# UNITED STATES PATENT AND TRADEMARK OFFICE

10/616,872

<b>Office Action Summary</b>	<b>Application No.</b>	<b>Applicant(s)</b>	
	10/616,872	THOMAS ET AL.	
	<b>Examiner</b>	<b>Art Unit</b>	
	Ghassem Alie	3724

### DETAILED ACTION

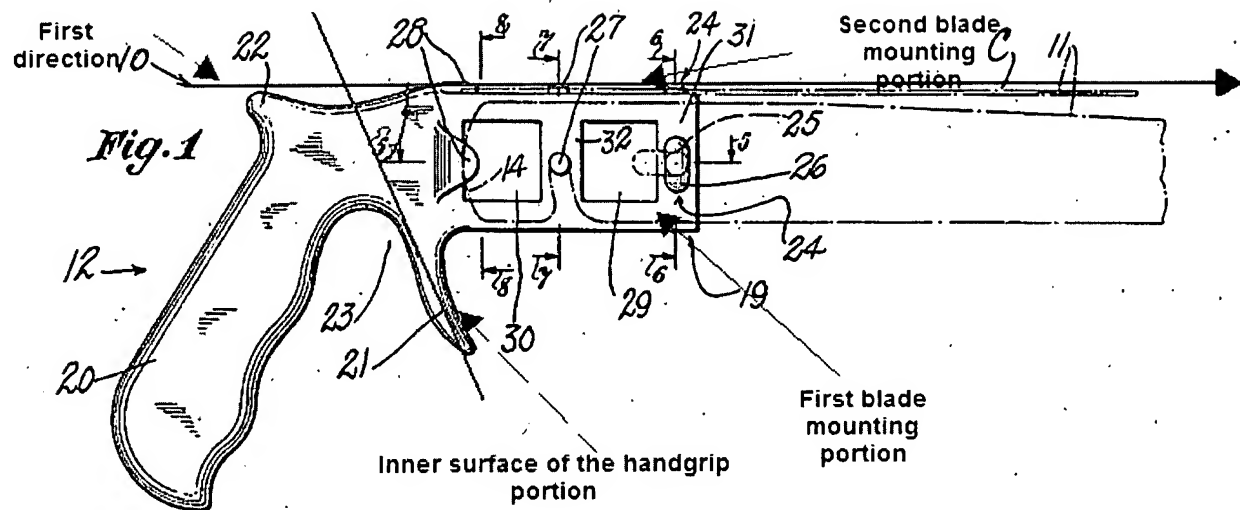
3. Claim 3, 6, and 23 are rejected under 35 U.S.C. 102(b) as being anticipated by Davey (2,017,895). Regarding claim 23, Davey teaches a hand saw 10 including a handle 12 having a handgrip portion 21 defining an inner surface 21A. It should be noted that handle 12 includes two portions 20, 21 that could be gripped by a user's hand. In this case, the second

portion 21 of the handle 12 is considered to be a handgrip portion, since it is gripped by a user's hand. Davey also teaches that the saw includes first and second blade mounting portions 24, 27. It should be noted that the T-headed stud 24 and the pin 27 at A or B defines the first mounting portion. The second mounting portion is defined by the T-headed stud 24 and the pin 27 at C. Davey also teaches that the first mounting portion being disposed on a side surface of the handle 12 and the second blade mounting portion being on a bottom surface of the handle 12. Davey also teaches a blade A-C removably mounted to one of the first and second blade mounting portions and extending away from the handle 12 in a first direction. Davey also teaches that the handgrip portion is sloped toward the blade so as to be oriented at an acute angle relative to the second blade mounting portion. It should be noted that the inner surface of the handgrip portion 21 is sloped toward the blade as the inner surface of the handgrip portion in the instant application. Davey also teaches that the first and second blade mounting portions each include a key 27 adapted to be received in and end slot in the blade.

7. Applicant's arguments filed on 05/11/07 have been considered but they are not persuasive. Applicant's argument that Davey fails to teach that the angle of the inner surface of the handgrip relative to the second blade mounting portion is an acute angle is not persuasive. As stated above, Davey teaches that the handgrip portion is sloped toward the blade so as to be oriented at an acute angle relative to the second blade mounting portion. It

should be noted that the inner surface of the handgrip portion 21 is sloped toward the blade as the inner surface of the handgrip portion in the instant application. See Fig. 1 above.
